**HISTORIC PRESERVATION REVIEW BOARD  
STAFF REPORT AND RECOMMENDATION**

| Address:           | <b>3428, 3430 and 3432 Oakwood Terrace, NW</b> |                       |
| Case Number:       | <b>13-335 (11-071)</b>                         |                       |
| Staff Reviewer:    | <b>Tim Dennée</b>                              | (x) Concept (renewal) |

*The property today, as subdivided into three lots.*

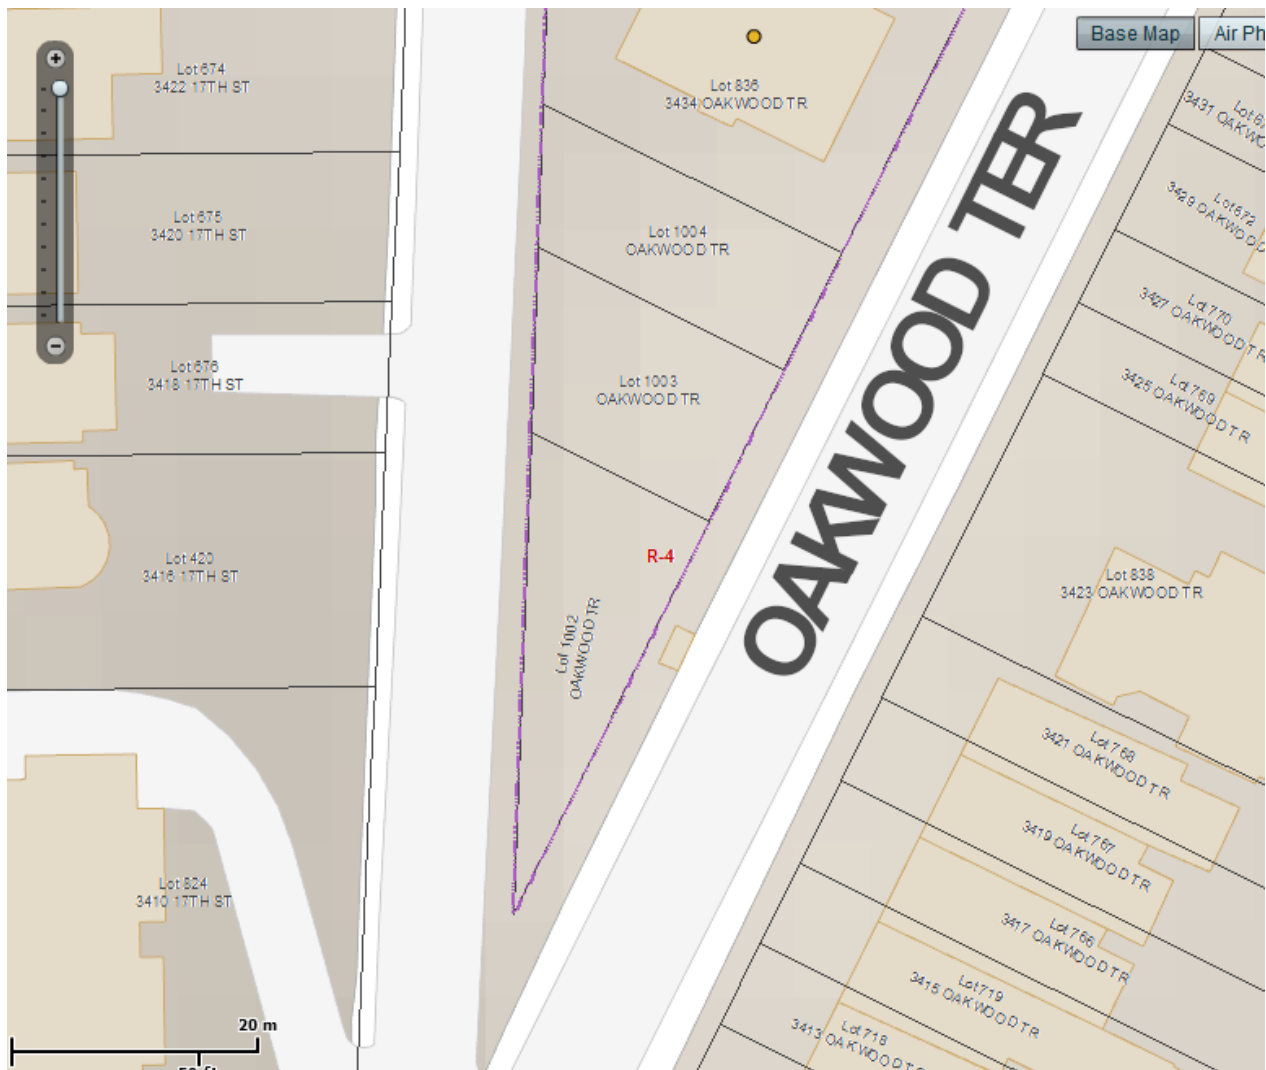
The applicant has agreed to construct the 17<sup>th</sup> Street site wall to match the materials and appearance of the granite retaining walls found along many of the Mount Pleasant streets, which is almost certainly the most compatible approach. The automobile gates within the wall remain to be developed, as are protections for the mature tree next to the gateway. The applicant is still considering providing a narrow, publicly accessible sidewalk along 17<sup>th</sup>.

Revisions have better unified the building(s), making them read more like related units, and the façade of the center units no longer resemble stair towers. The horizontal wood elements have been removed from the southernmost and northernmost units. Most of the French doors have been removed from the facade, and the fenestration shows more pattern. The cornice detail is more elaborated than on the previous submission. Two belt courses have been introduced between the floors, and although the lower one may be effective in delineating a base, the upper one cuts the body of the building too much horizontally; the panels at the parapet are sufficient to suggest a proportional top to the building. It is not clear if the vertical lines indicating breaks between units will be perceptible in the real world, i.e., whether there will be a reveal or even a cold joint. But that is of little importance, as such breaks were never necessary to demarcate individual rowhouses.

Additional detail has been added in the form of brick panels at the parapet, evocative of similar details from modest, mid- to late-1920s rowhouses. There are also panels at the base of first-floor window openings, something that is probably unnecessary, and inadvisable for maintenance reasons. The HVAC equipment is not shown, but to the extent that it appears on the roof, it should be centered as much as possible, so it can be screened behind the parapet. The applicant has opted not to add canopies over the main entrances, something that was suggested by the staff as a way to establish a rhythm analogous to porches, but in a more confined space. The lack of canopies makes the building cleaner, as such elements can be visually unsuccessful, but they had been suggested out of experience with homeowners wanting to retrofit their entrances with them. As an alternative, the applicant proposes to set the doors well back into their openings to provide some cover.

As yet, there are no elevation drawings of the narrow north and south ends of the building.

*The HPO recommends that the Board reaffirm its earlier finding and renew the conceptual approval of the proposed plan, height, massing of the new construction, including the 17<sup>th</sup> Street wall, with a delegation of permit review to staff, but with the applicant to incorporate recommendations the Board may make as to finer revisions.*
